**Supplemental Information Letter
Delta-Wauseon 138 kV Transmission Line
Tap to Nature Fresh Farms Project
Case No. 15-2081-EL-BLN**

DELTA-WAUSEON 138 kV
TRANSMISSION LINE TAP TO NATURE
FRESH FARMS

138 kV WOOD POLE, SINGLE CIRCUIT,
BRACE POST INSULATOR, DELTA TANGENT

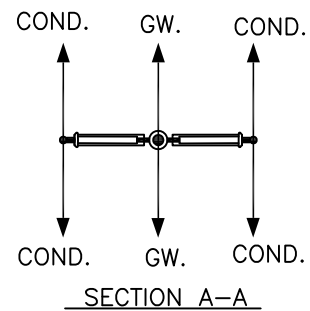
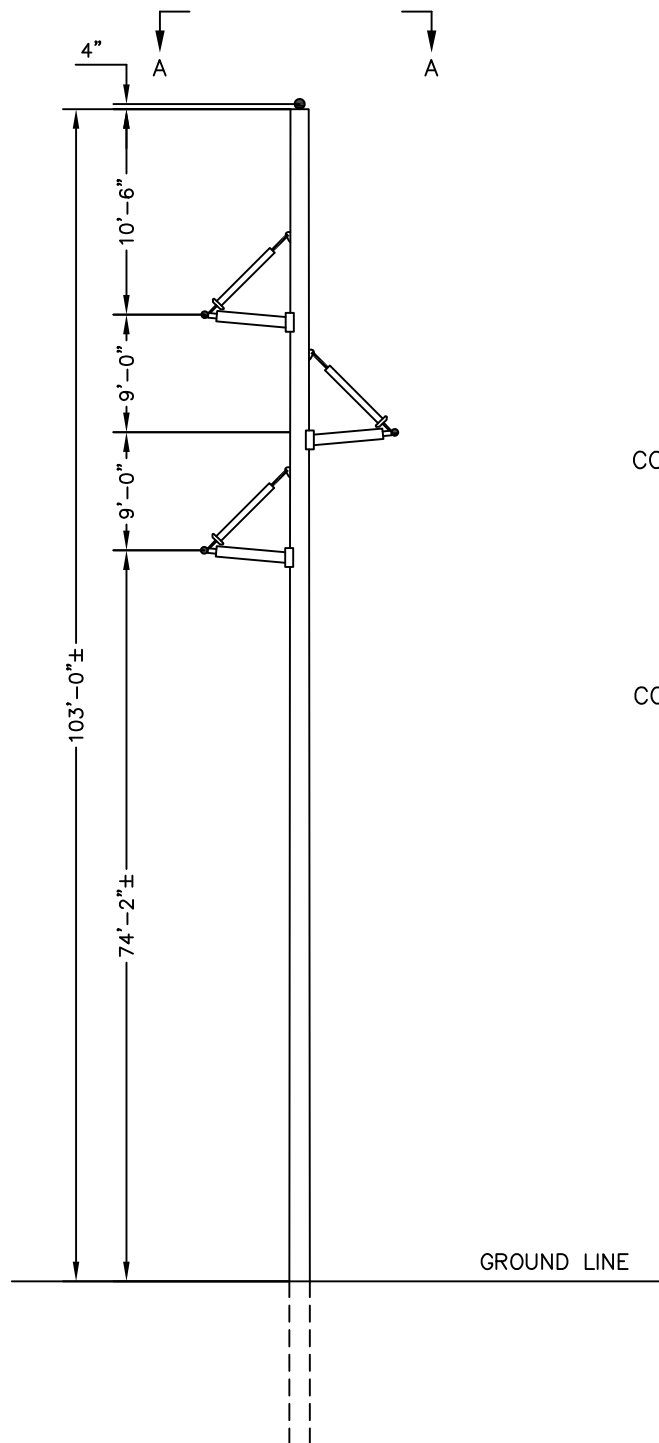
1. Structure 61 will still be replaced, as indicated in the LON, but it will be replaced with a 138 kV Wood Pole Structure, as depicted in Attachment 2, as opposed to the switch structure identified in the LON. Structure 61 will be installed approximately 20 feet to the southeast of the existing structure location, removes unnecessary line angles from the transmission line.

138 kV WOOD POLE, SINGLE CIRCUIT,
SWITCH

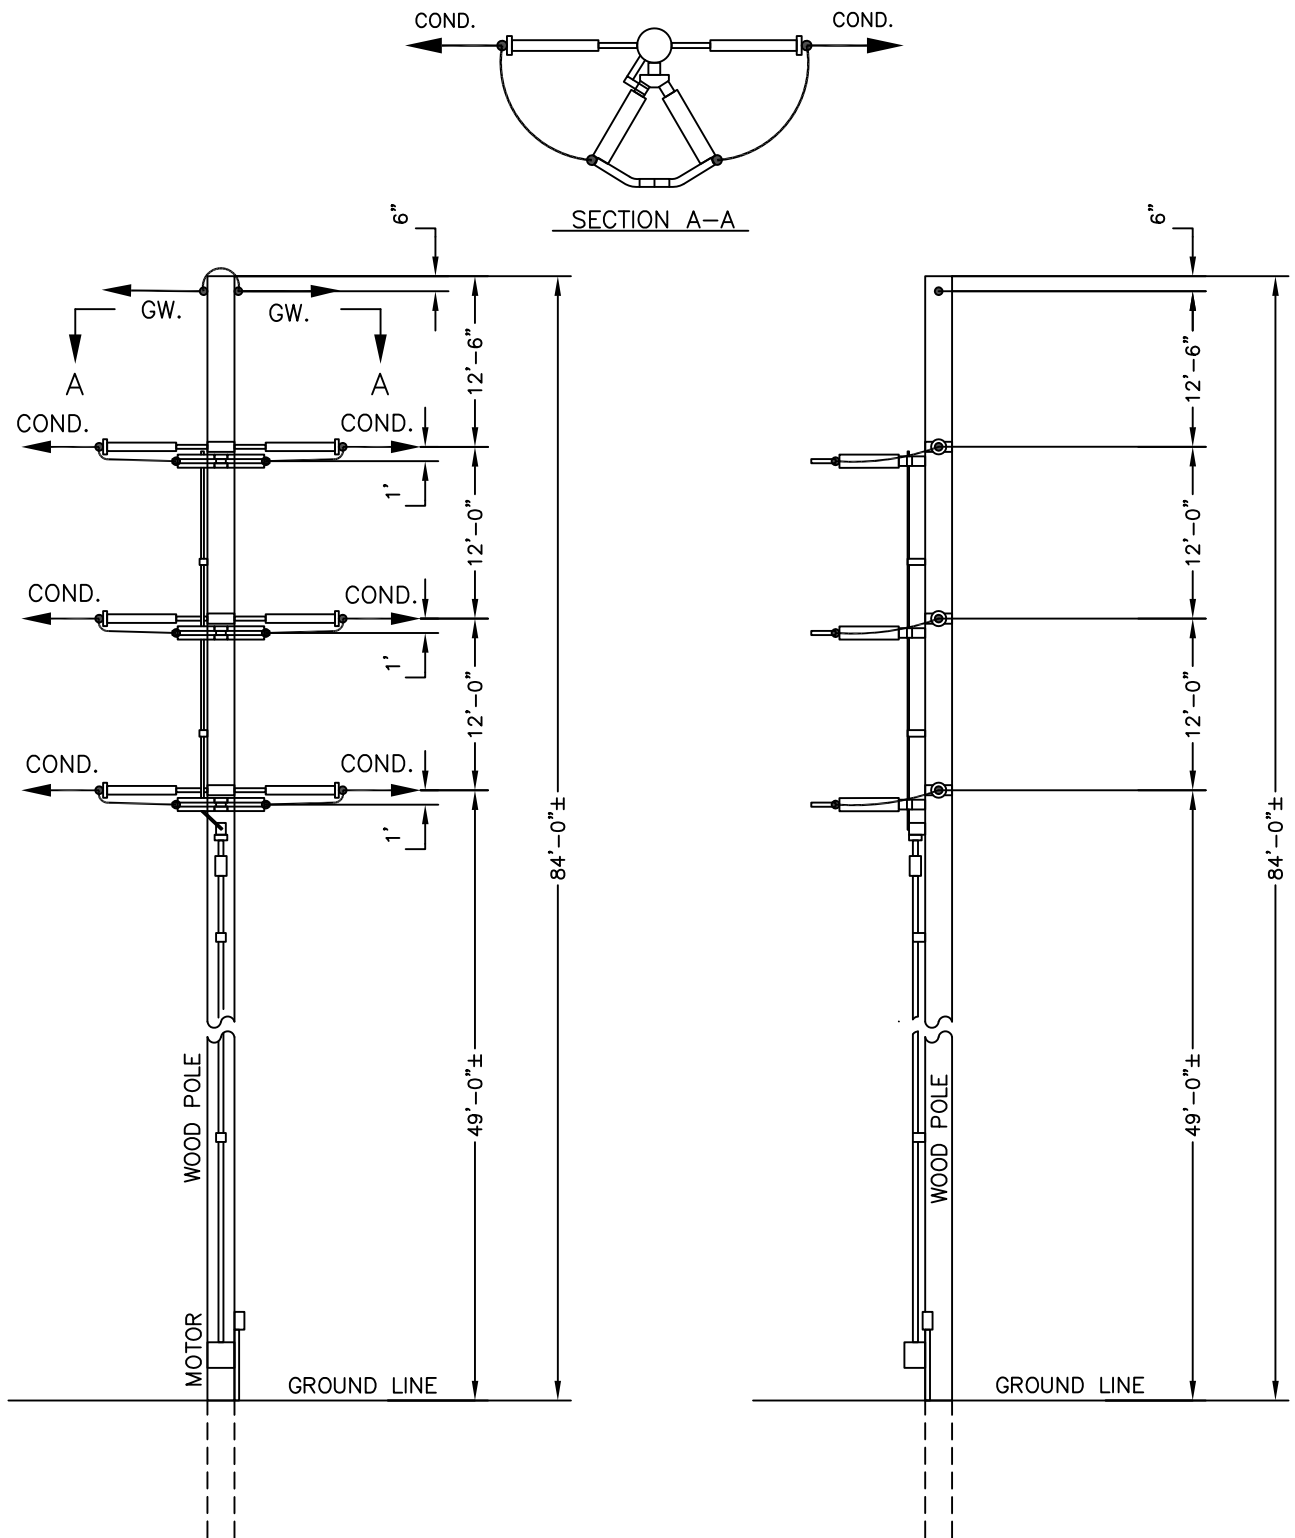
2. Structure 60 will be replaced with a 138 kV Wood Pole, Single Circuit, Switch Structure, as depicted in Attachment 3. The new Structure 60 will be located at approximately the same location as the existing structure.
